Department of Veterans Affairs  
Medical Center  
3200 Vine Street  
Cincinnati, OH 45220

## Logistics HVAC Modifications

Heapy Engineering No. 2015-04025

**Date: November 17, 2015**

H1

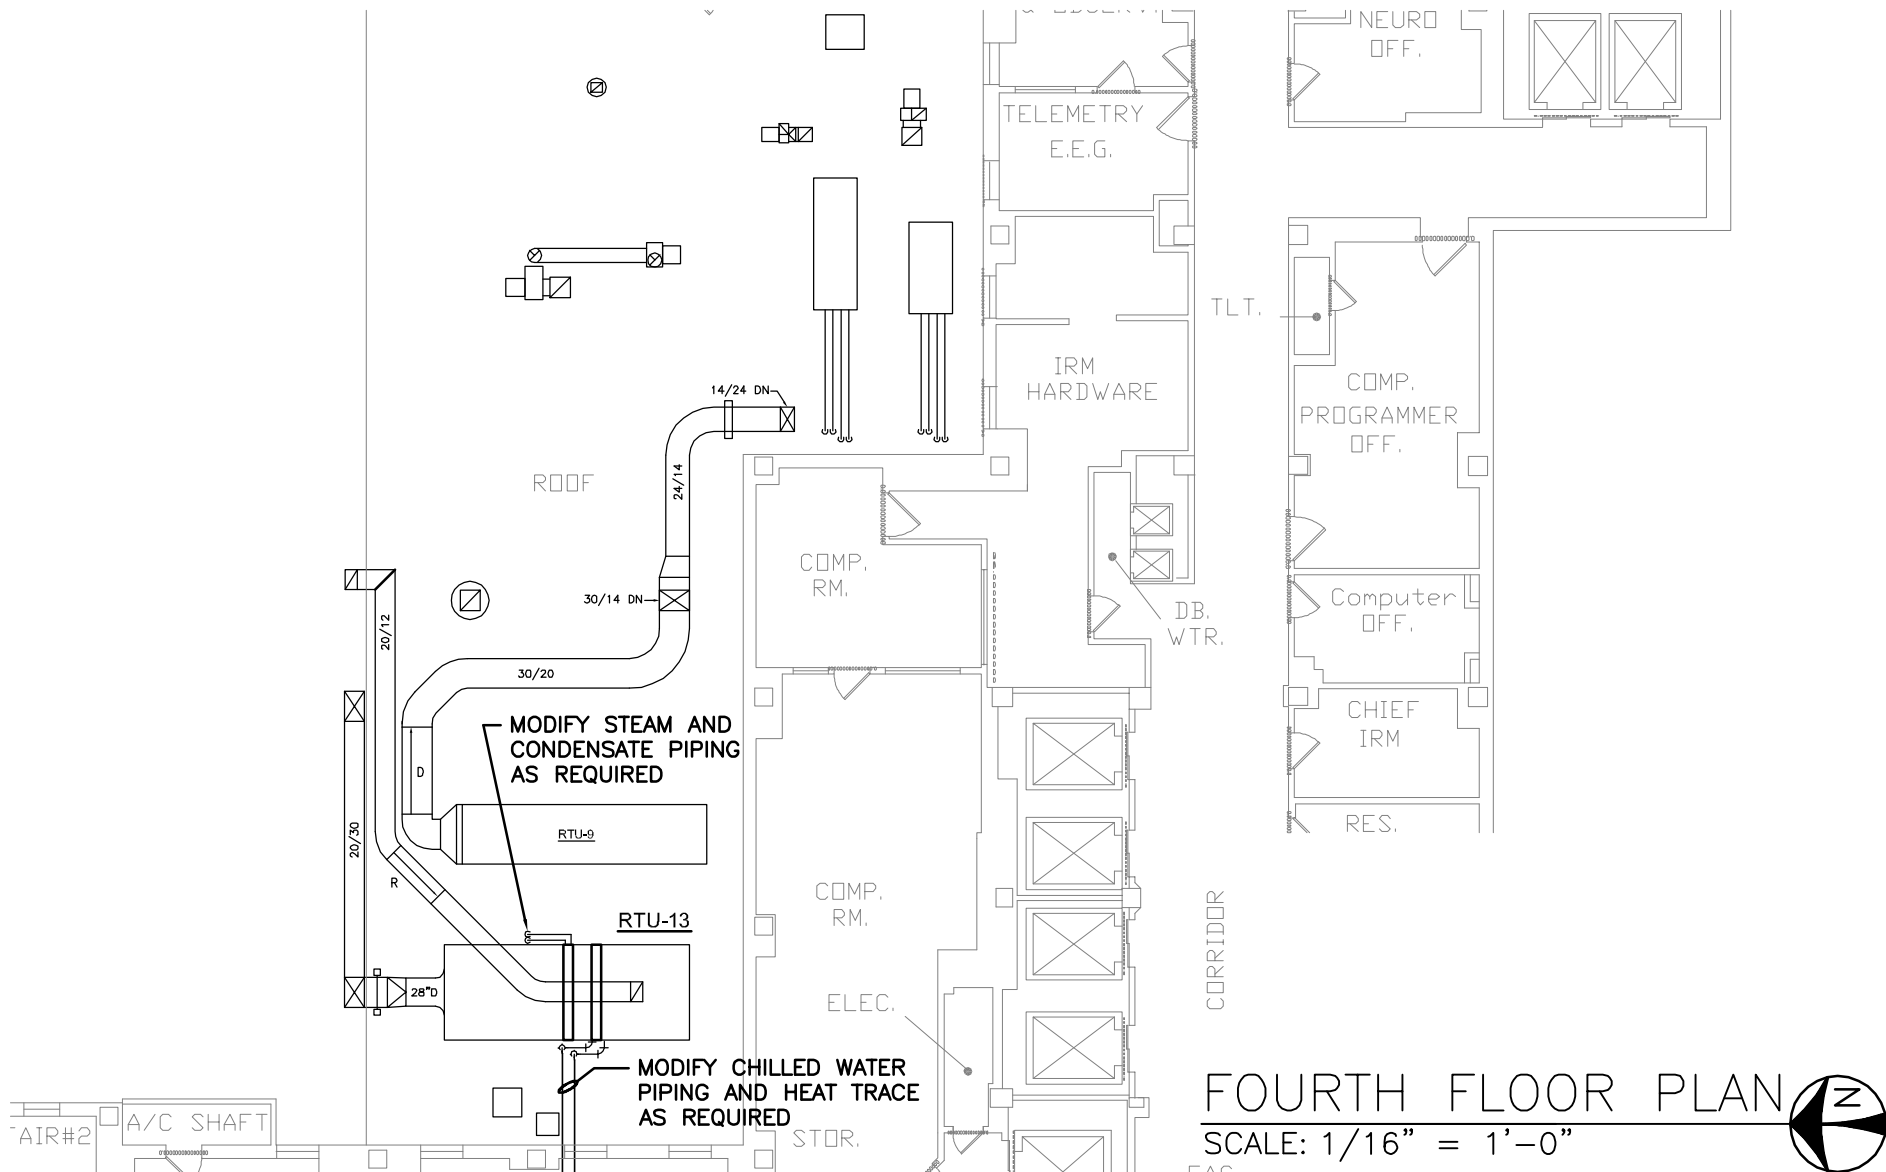
Disconnect the chilled water piping from the cooling coil and remove back as far as necessary for access to the coil. Remove heat trace as required and protect for reinstallation. Remove the cooling coil and associated blank-offs, coil supports/frames, drain pan, etc. from the unit and set aside for relocation. Refer to attached instruction drawing. Remove freeze-stat for relocation to preheat coil.

Disconnect the steam and condensate piping from the heating coil and remove back as far as necessary for access to the coil. Remove all exterior piping insulation for replacement. Remove the heating coil and associated blank-offs, coil supports/frames, etc. from the unit and set aside for relocation. Refer to attached instruction drawing.

Install the heating coil and associated blank-offs, coil supports/frames, etc. in the section where the cooling coil was. Refer to attached instruction drawing. The coil will now be in the preheat position. Extend the piping and connect to the coil in its new location. Provide new shut-off valves and unions at the coil connection. All piping work shall be above the roof. Insulate all exterior piping per specifications. Relocate freeze-stat from chilled water coil and install on steam preheat coil.

Install the cooling coil and associated blank-offs, coil supports/frames, drain pan, etc. in the section where the heating coil was. Refer to attached instruction drawing. Extend the piping and connect to the coil per the attached chilled water coil piping detail. All piping work shall be outside of the building. Re-install heat trace and re-insulate piping per specifications.

Replace sheaves for supply fan and balance fan to 6,210 CFM.

Replace sheaves for return fan and balance fan to 2,275 CFM.

VIEW: General Arrangement  
 DRAWN: 01-August-2008 (10:34)  
 JOB NAME: VA Cinti AHU Replacement  
 UNIT TAGGING: RTU-13  
 MODEL: RDS800C

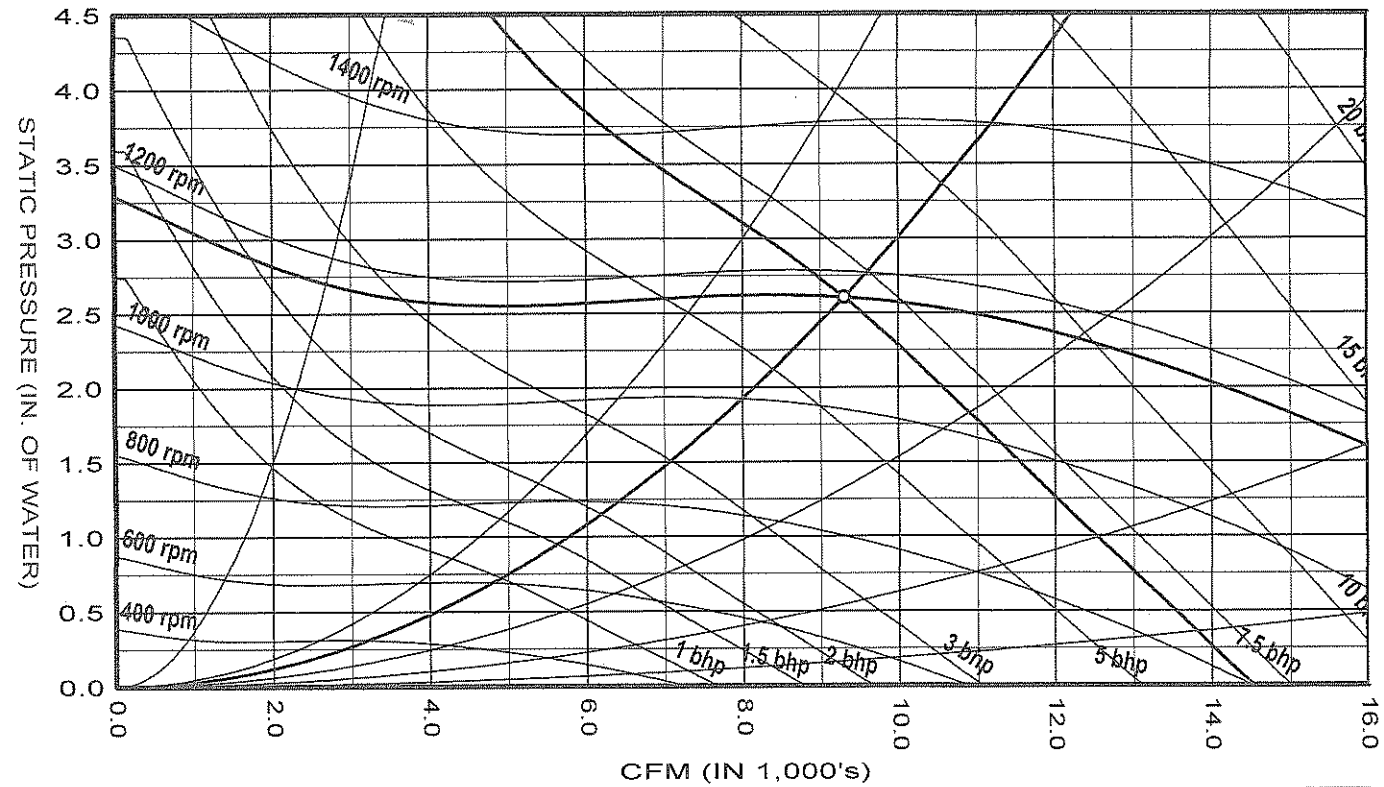
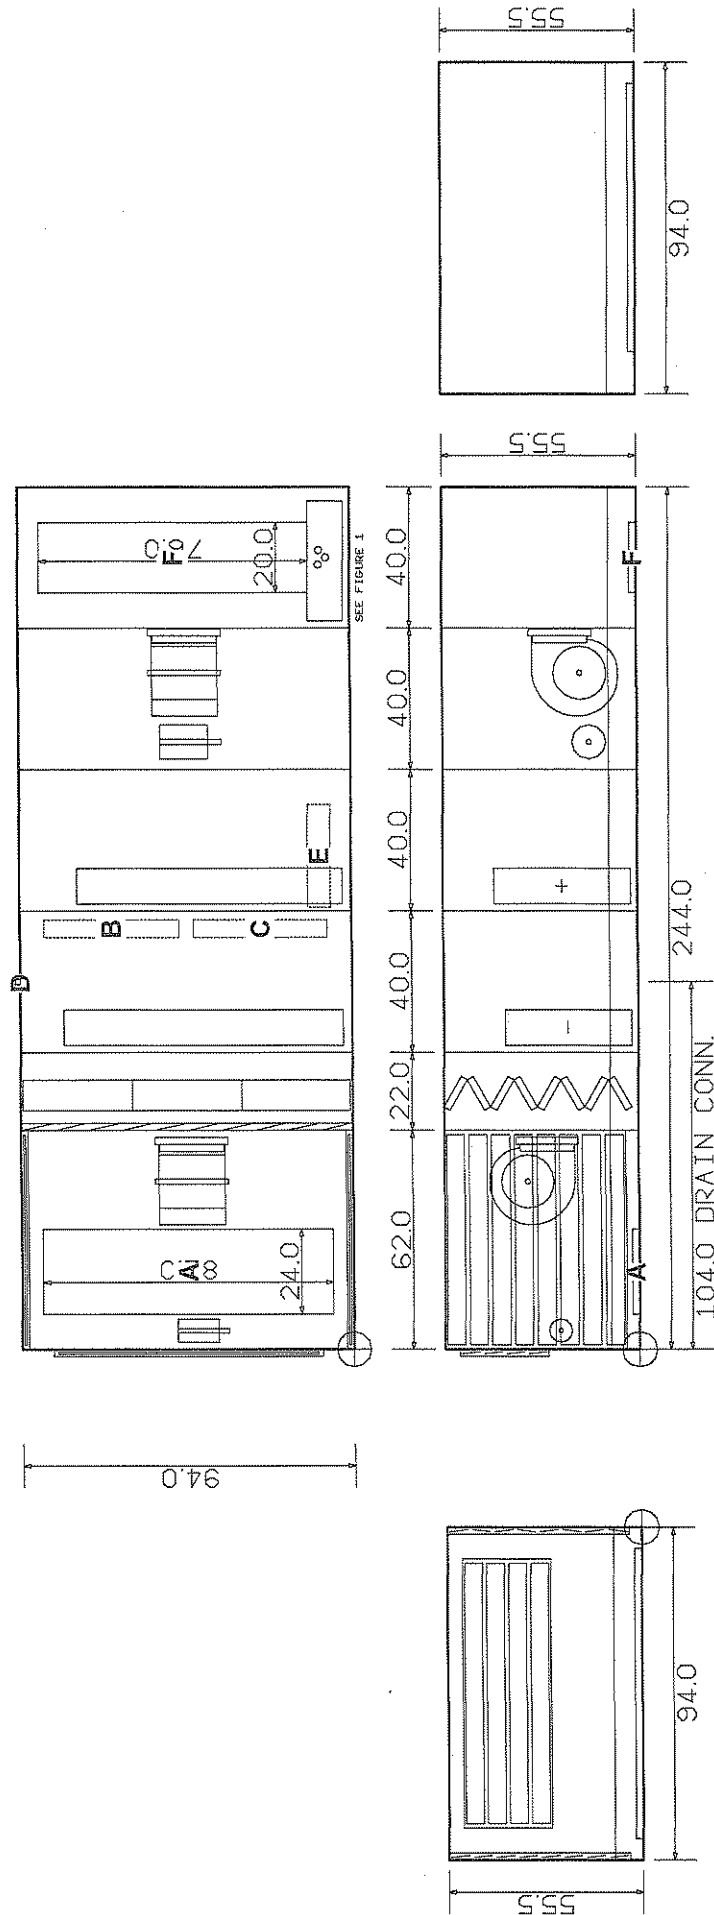
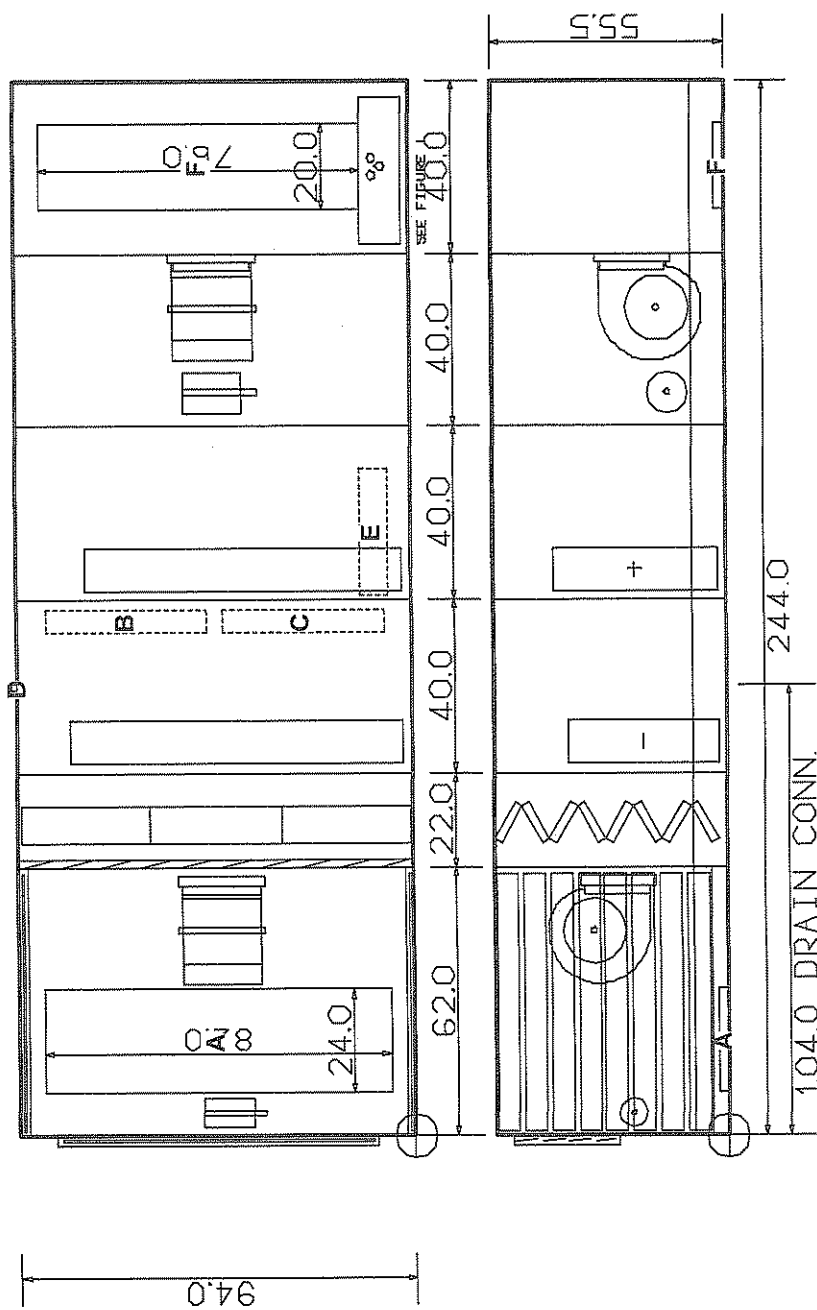
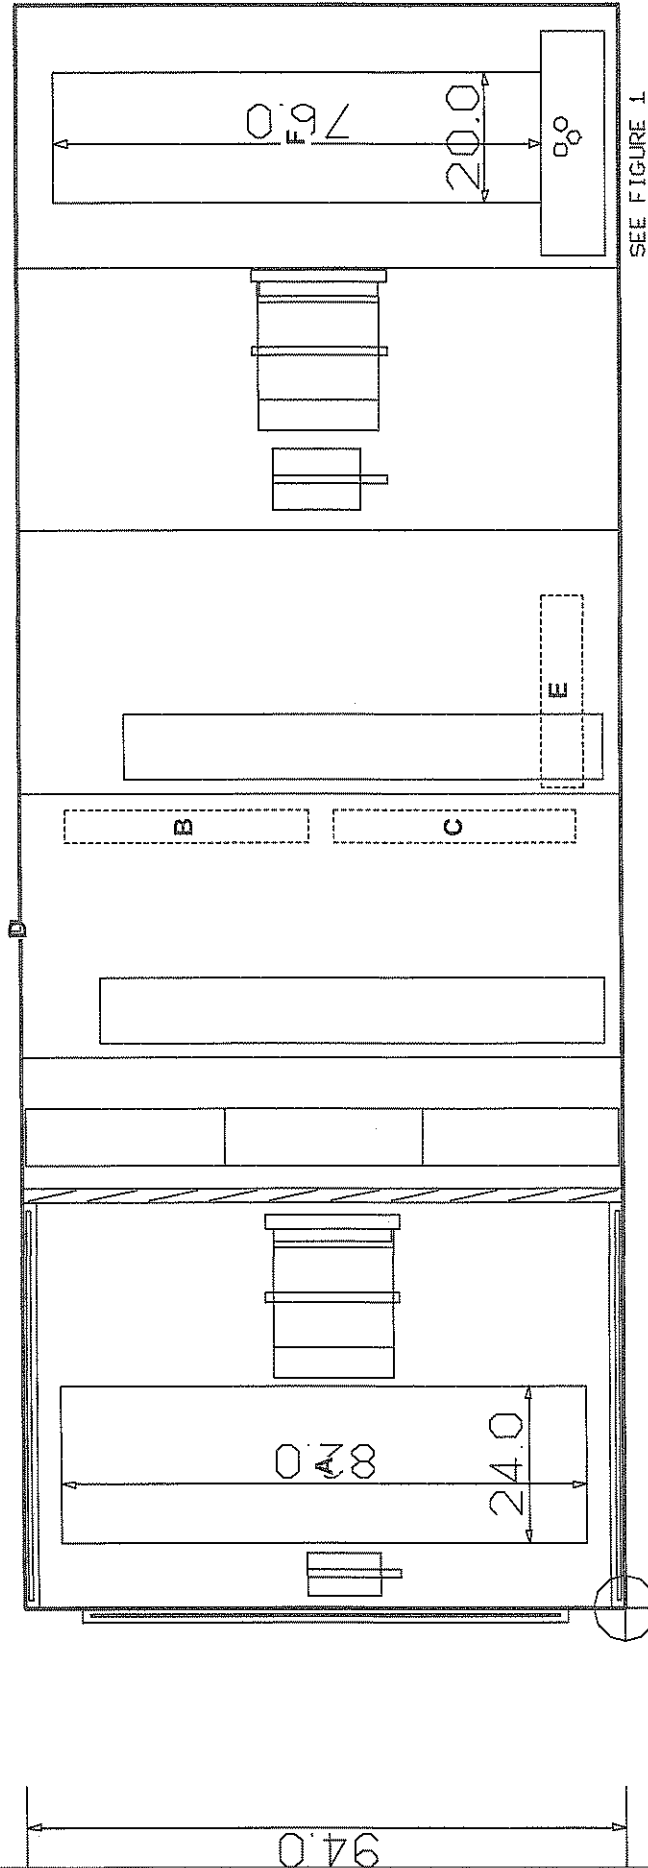
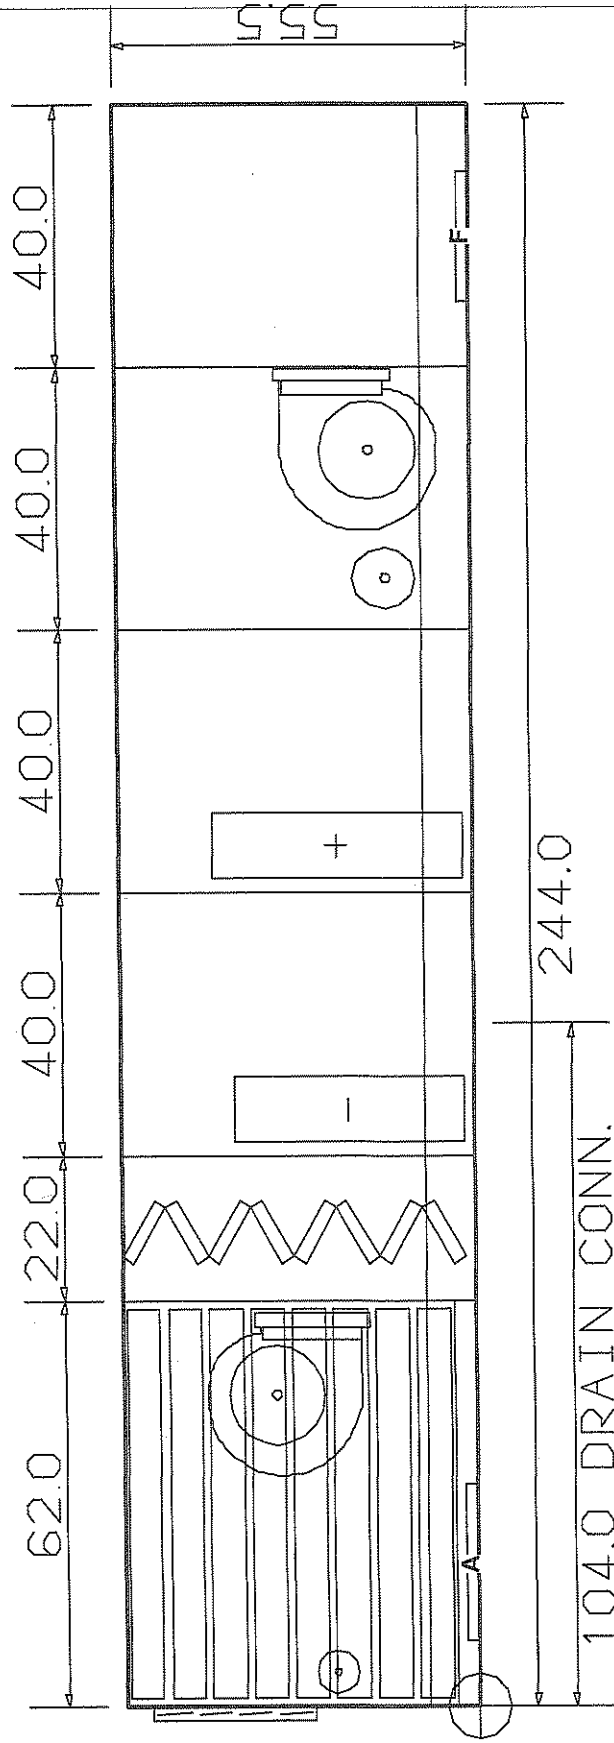
1. The insulation for floor panels shall be a R value of no less than 8, see specification 237413 (2.1)(C)(4).
2. Confirm controls have been coordinated with controls supplier.

**H2**

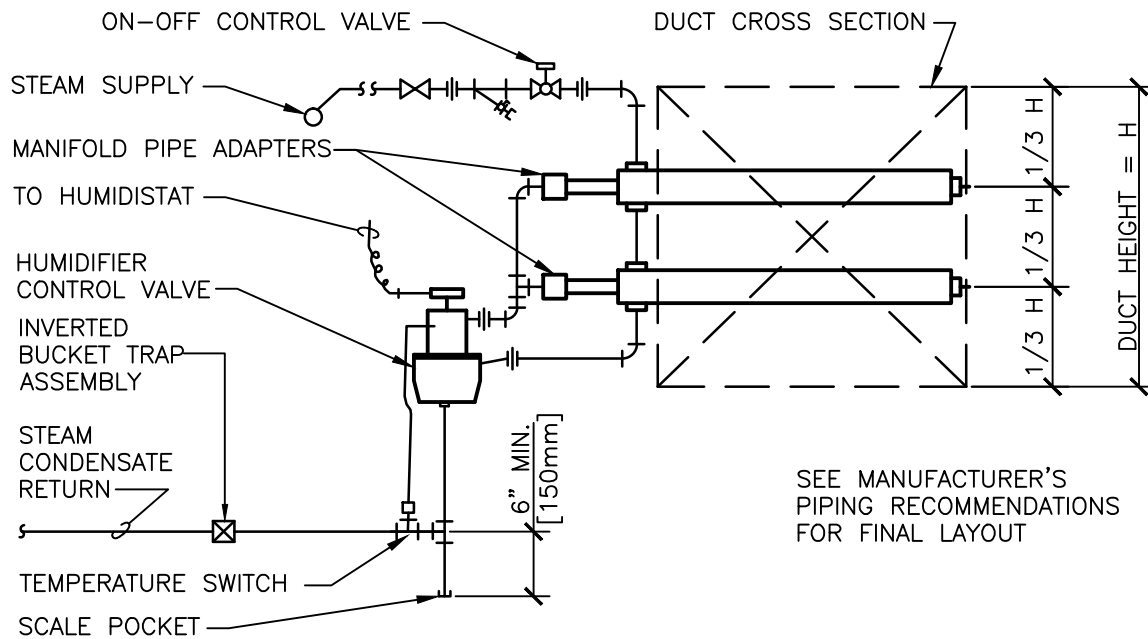
Provide duct mounted humidifier with single dispersion tube sized for 14.0 lbs/hr and maximum 12" absorption distance in 20x10 duct upstream of CVD1 (1860 CFM). Extend 0.75" steam and condensate piping from the 2.5"-30 PSI steam and 1.5" condensate piping in the north wall at column lines O / 12.1 and connect to humidifier per the attached humidifier piping detail. Provide duct mounted humidity sensor in return duct from Clean Supply Room B201. Humidifier to maintain 25% RH. Provide humidistat on wall in Clean Supply Room B201. Controls shall be stand alone.
